DFM REPORT OF

Y060-001

Part Name: UPPER_PULT

Mold Number: **Z060**

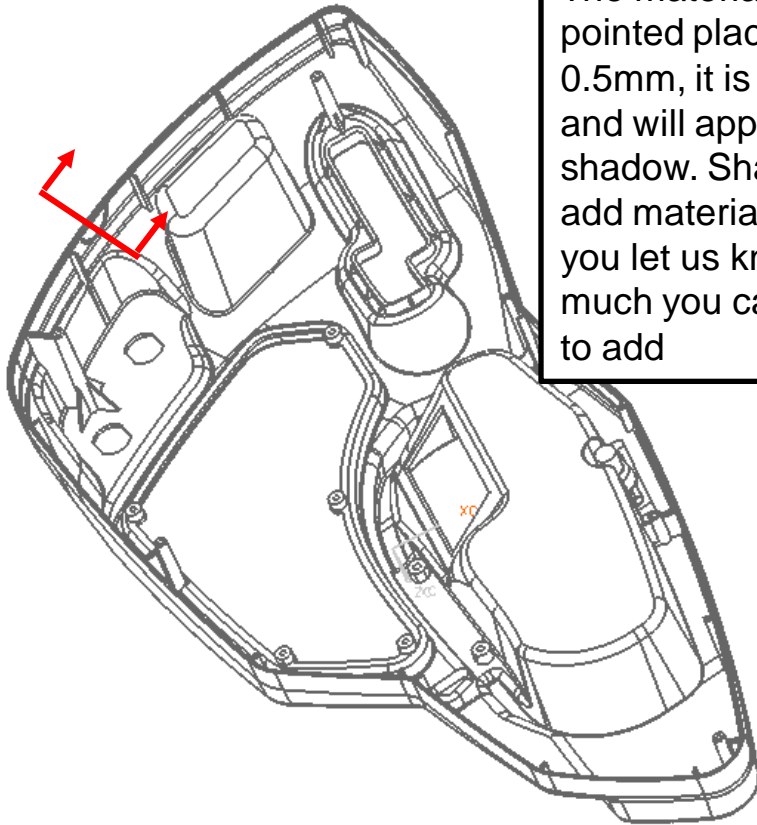
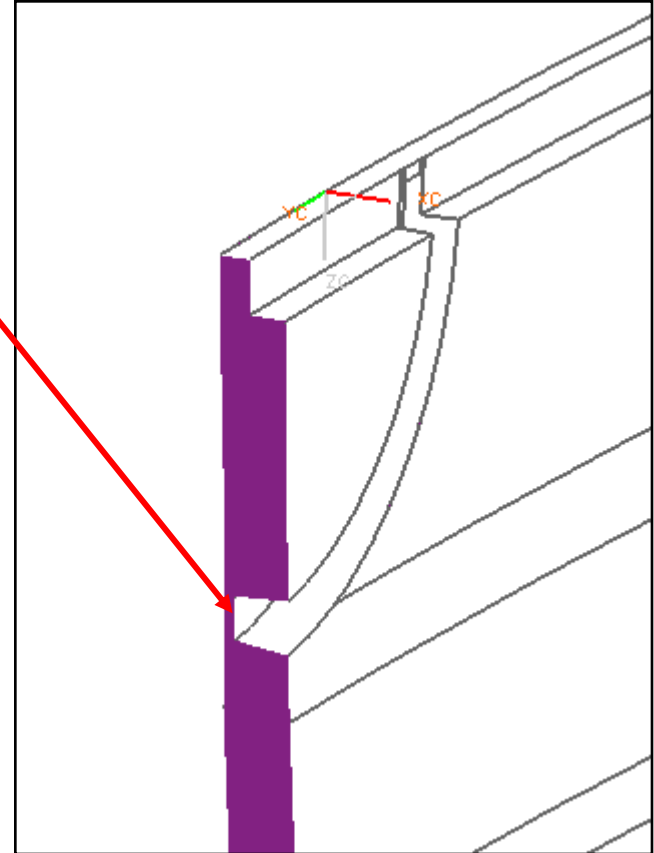
The material on the pointed places is only 0.5mm, it is too thin and will appear shadow. Shall we add material? Can you let us know how much you can accept to add

Thickness Analysis (shrinkage/strength/sink mark)

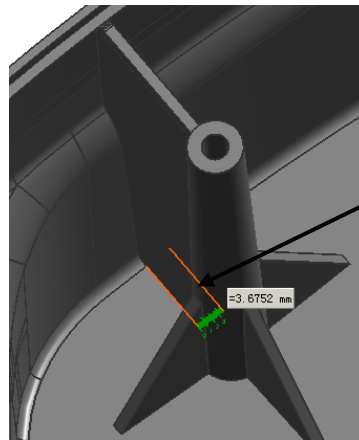
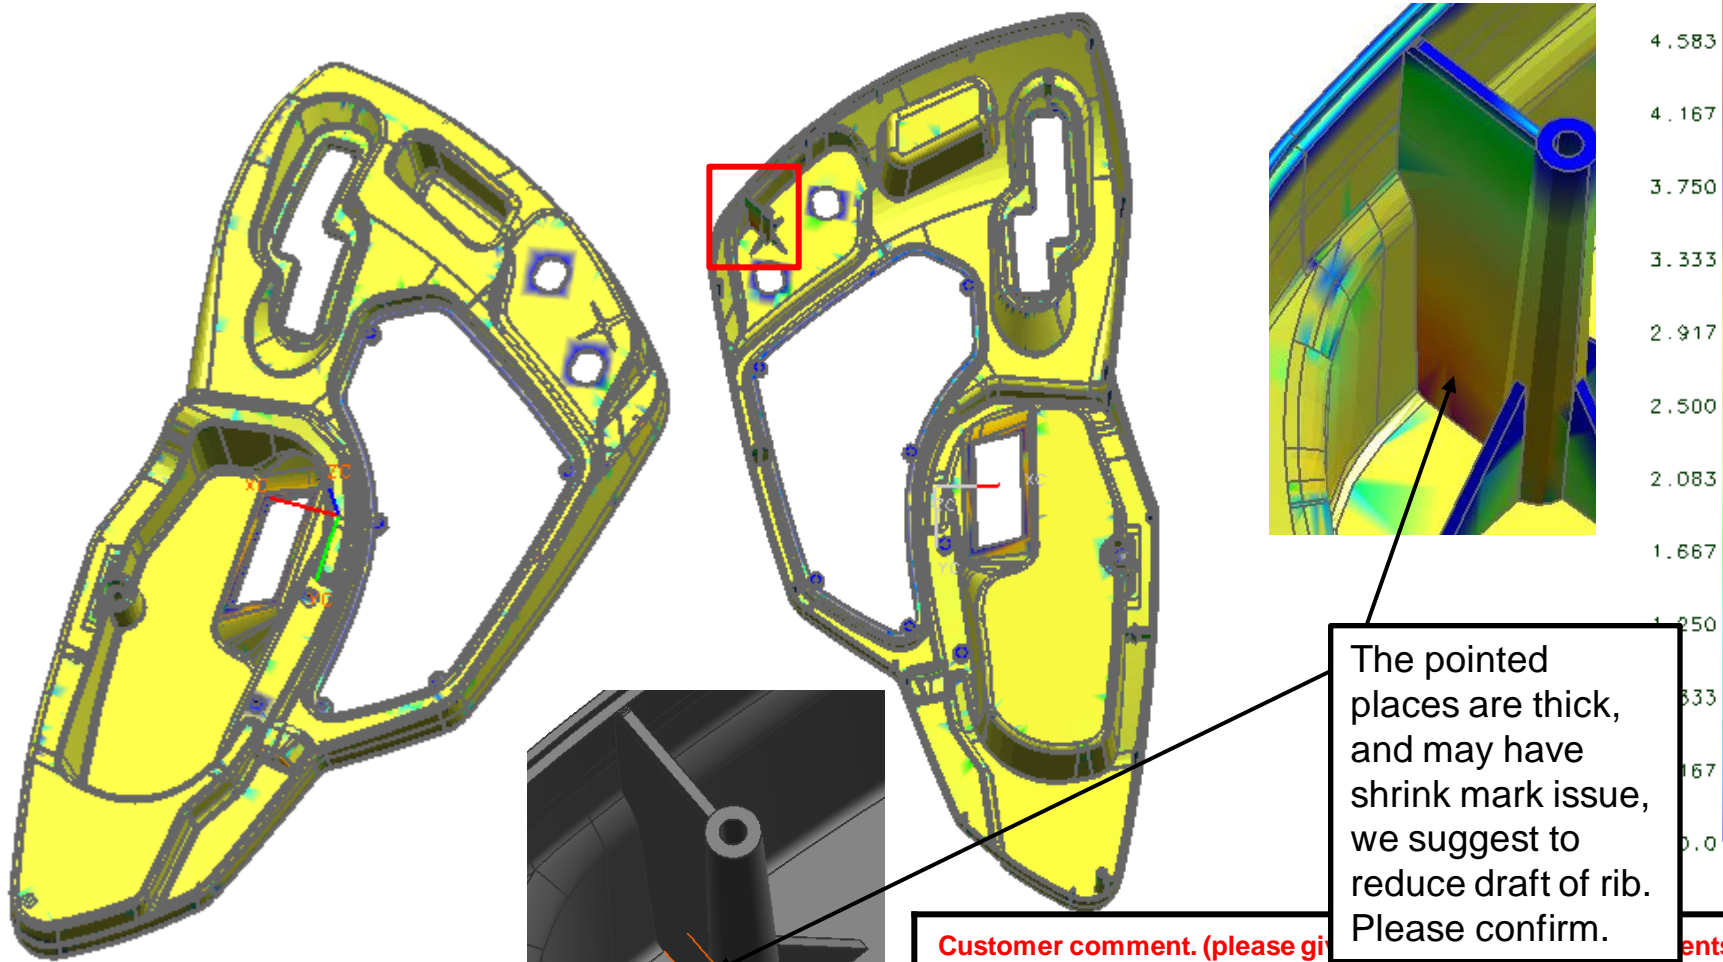
The pointed places are thick, and may have shrink mark issue, we suggest to reduce draft of rib. Please confirm.

Thickness Analysis (shrinkage/strength/sink mark)

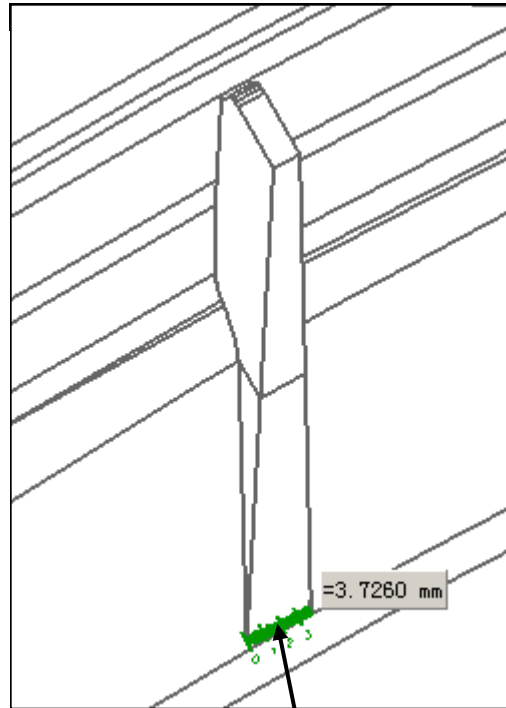
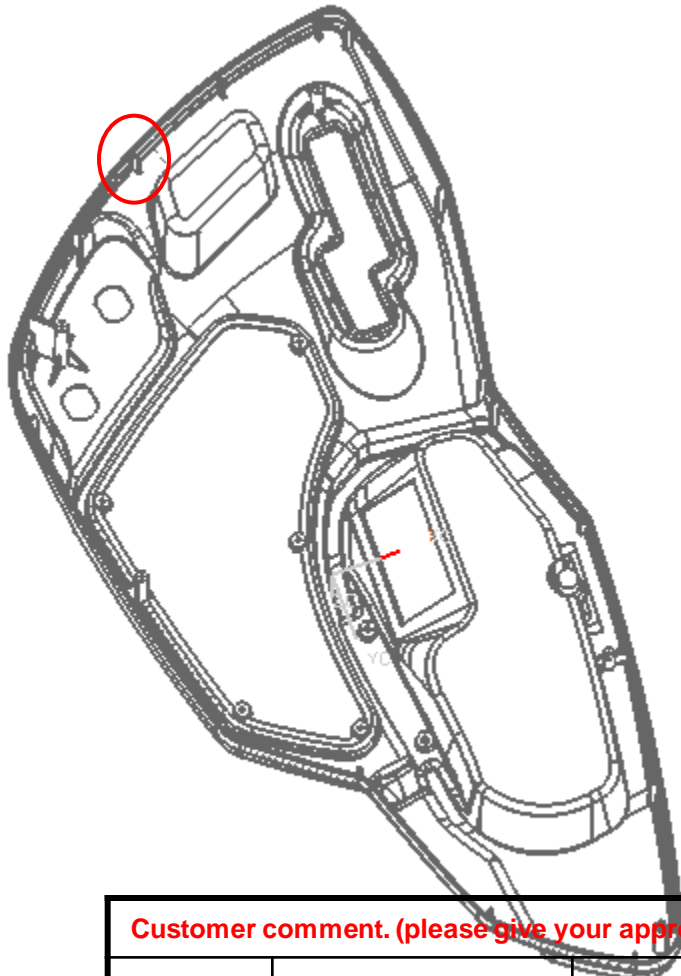
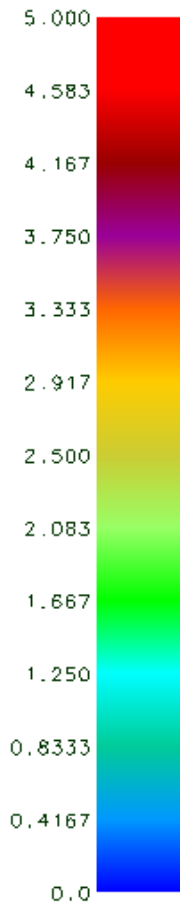
The material on the pointed places is too thick and will have shrink mark. we suggest to make the max thickness 1.8mm, min thickness 1.2mm. Please confirm

Draft angle information cavity

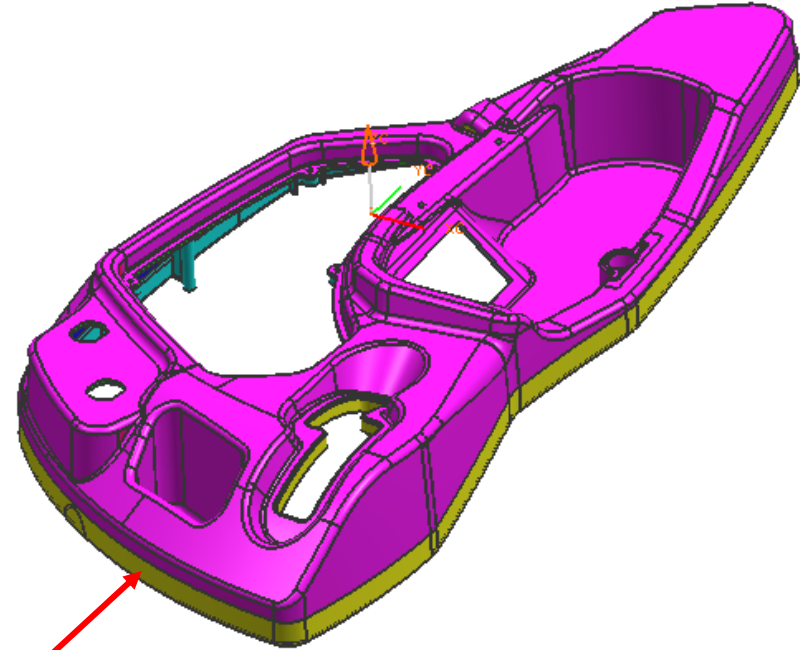
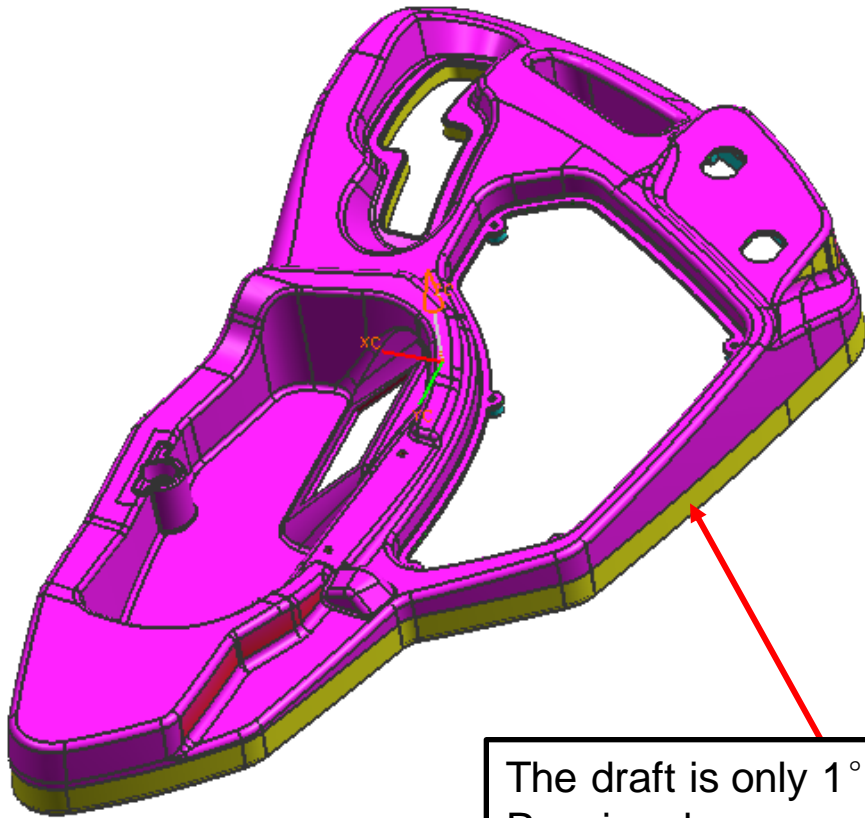
The draft is only 1° , as texture is making in Russia, please confirm with texture supplier if the draft is acceptable.

Issue

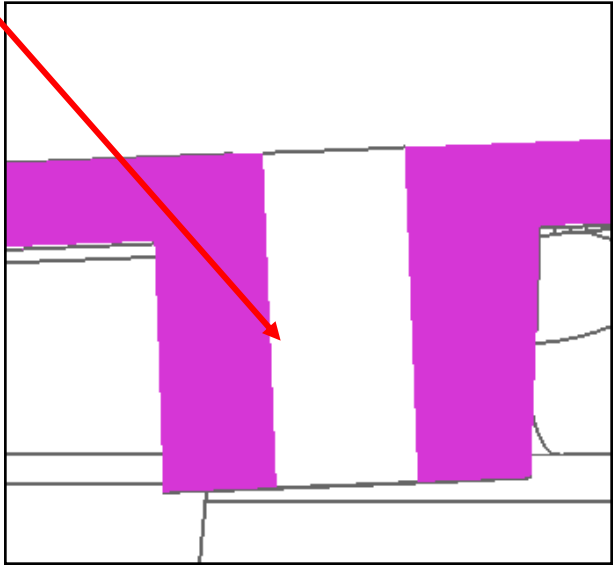
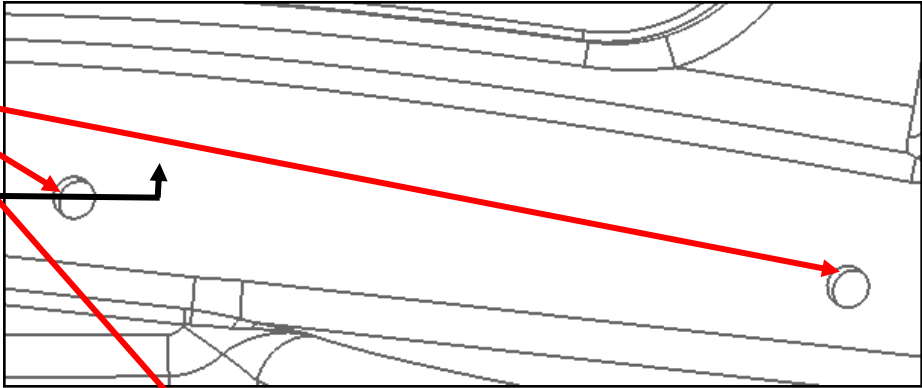
The hole is undercut, we suggest to make it straight. Please confirm

Engraving

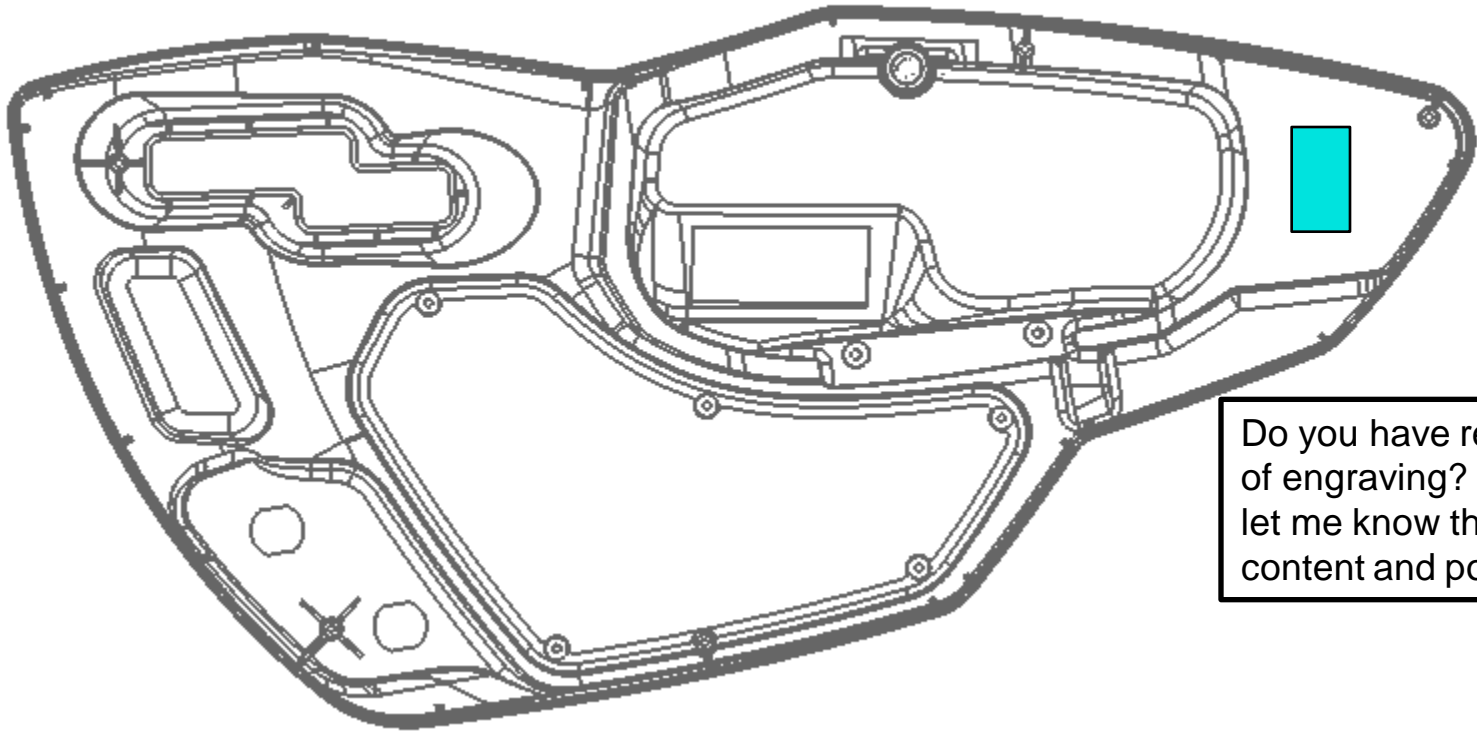
Do you have request of engraving? Please let me know the content and position .

Cosmetic requirement

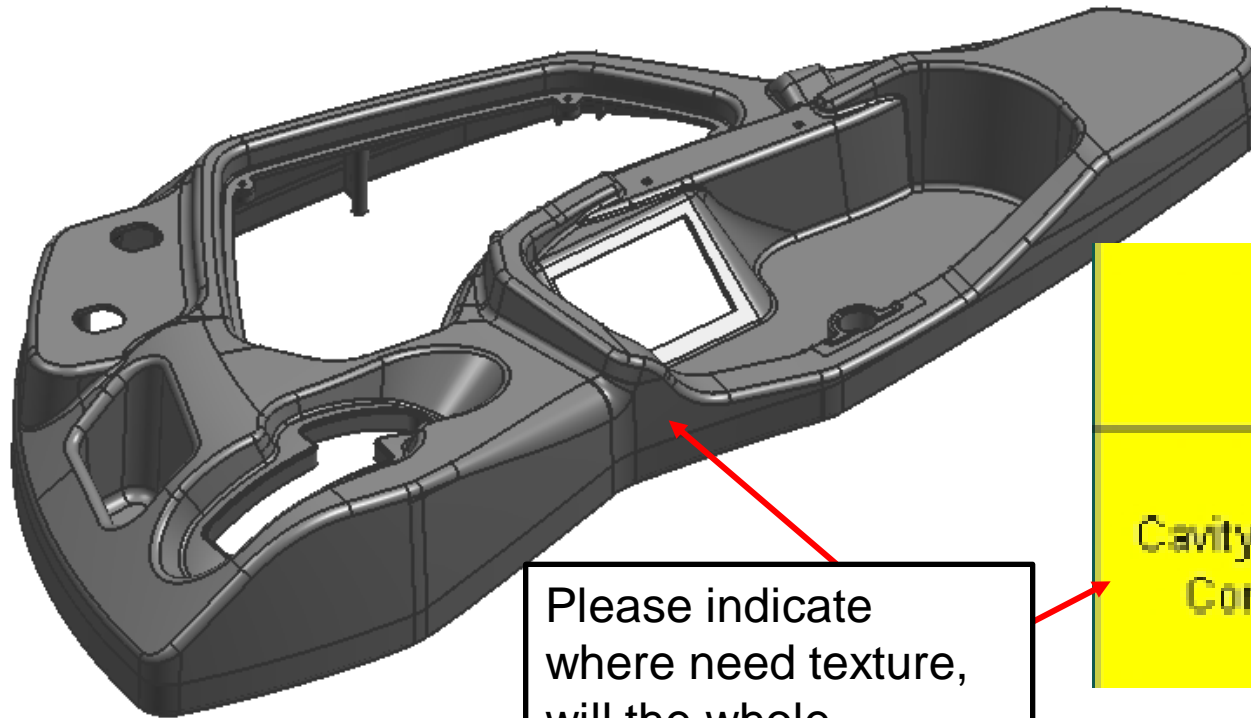
Please indicate where need texture, will the whole appearance surface need making texture?

We need cosmetic specification to make this Detailed surface finishing. Please highlight it.
